JOINT REGIONAL PLANNING PANEL (Sydney East Region)

JRPP No	2015SYE004 – DA 253/2014
DA Number	253/2014
Local Government Area	Manly
Proposed Development	Demolition of existing "Elsie Hill Building, construction of a six (6) storey building "Centre for Child Health and Learning" over two (2) levels of basement car parking for fifty three (53) cars and the use of the building as clinical, educational and office facilities, alterations to Drummond House to connect to the new centre and landscape works
Street Address	14-18 Wentworth Street, Manly (referred to as 22 Wentworth Street in Council's Mapping System).
Applicant/Owner	Applicant / Owner: Royal Far West Children's Health Scheme
Number of Submissions	Forty (40) submissions received including one (1) confidential, submission, and a petition of thirty-six (36) signatories. (Note: only 17 signatories are included in the total number of submissions received as only one submission is admissible per household).

Assessment Report and Recommendation Cover Sheet

ADDITIONAL SHADOW CAST BY THE PROPOSED DEVELOPMENT COMPARED TO APPROVED CONCEPT PLAN AT 11.30AM JUNE 21 (SOURCE: SEE).

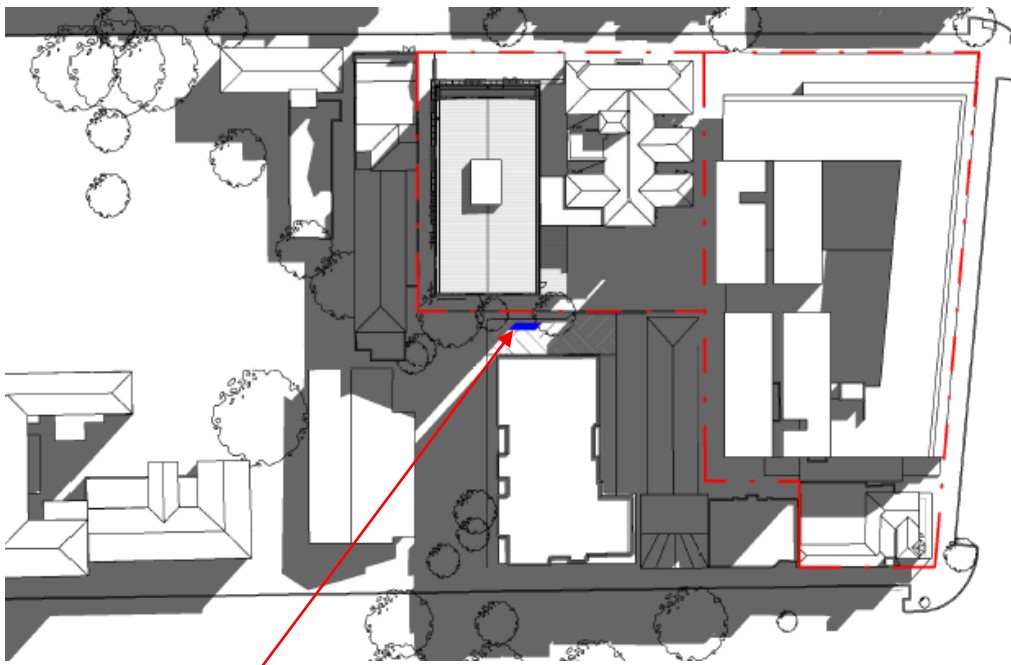
The Oral Health Centre extends beyond the envelope of the Centre adjacent to the Drummond House rear addition. Compared to the approved Concept Plan, the key points of departure are:

- At 11:30am, additional shadow from the Oral Health Centre is cast onto a portion of the rear courtyard of the adjoining residential flat building at 25-27 Victoria Parade, Manly. The adjoining courtyards can be seen in the photograph below:

On balance, the increase in shadow cast by the new Oral Health Facility is considered to be minor and consistent with the shadow cast by the approved Concept Plan.

ADDITIONAL SHADOW CAST BY THE PROPOSED ORAL HEALTH FACILITY COMPARED TO APPROVED CONCEPT PLAN AT 1PM (21 JUNE)

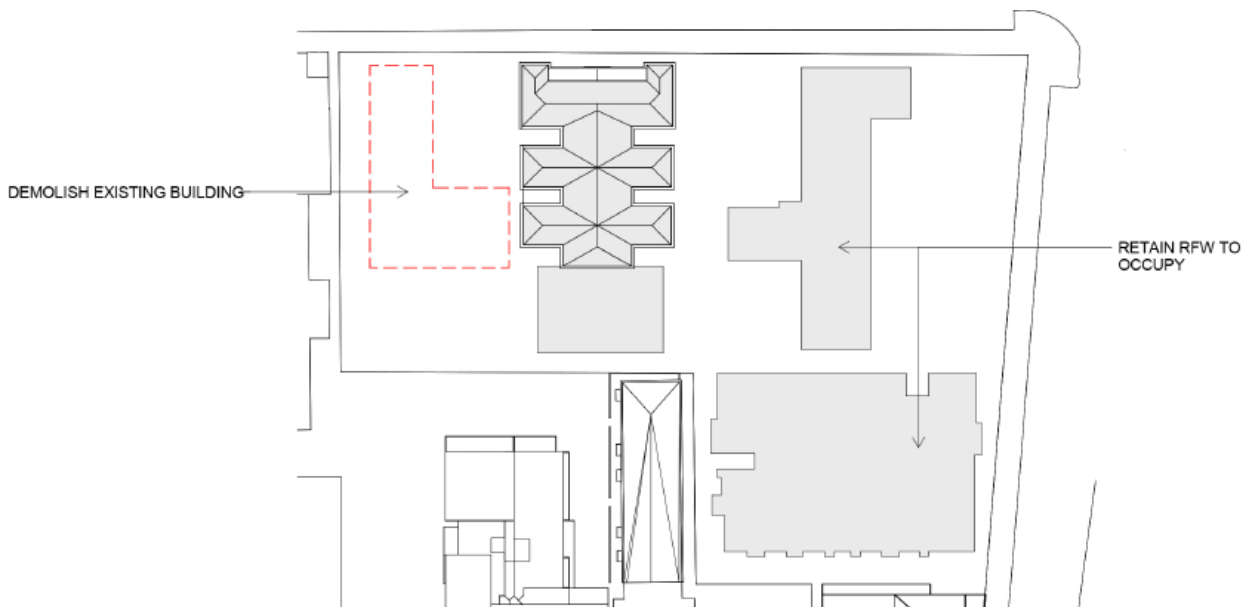
- Around Midday, the shadow falls within the shadow of a standard 1.8m high boundary fence.
- At 1pm, additional shadow from the Oral Health Centre is cast onto the same area, to a lesser extent than at 11:30am. The extent of the shadow is indicated in blue in the figure below:

PLANS SHOWING PROPOSED STAGING AS IT RELATES TO THE REAR OF DRUMMOND HOUSE (SOURCE: UPDATED CAMPUS STAGING STRATEGY REPORT)

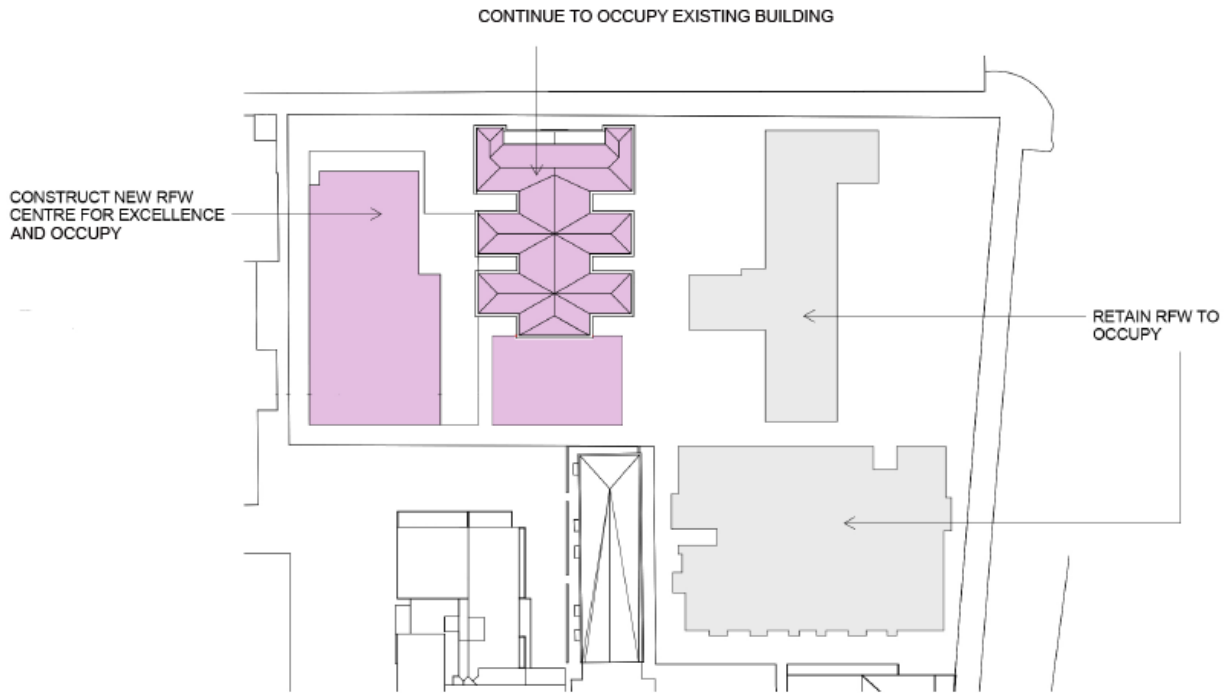
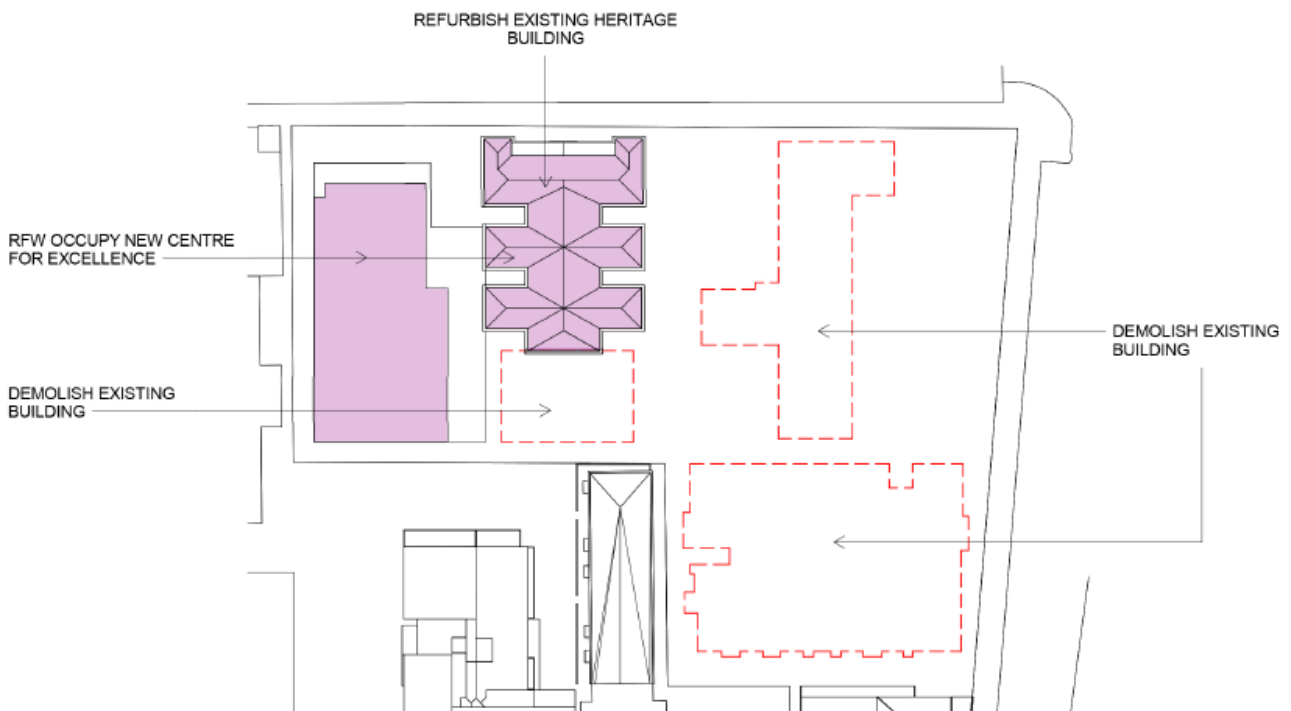
While the rear of Drummond House is maintained, the existing shadow cast by this building on the adjoining properties remains unchanged from the existing situation. The diagrams below show how the deletion of Drummond House has been moved from Stage 2 to Stage 3 in order to facilitate the continued operation of the RFW site.
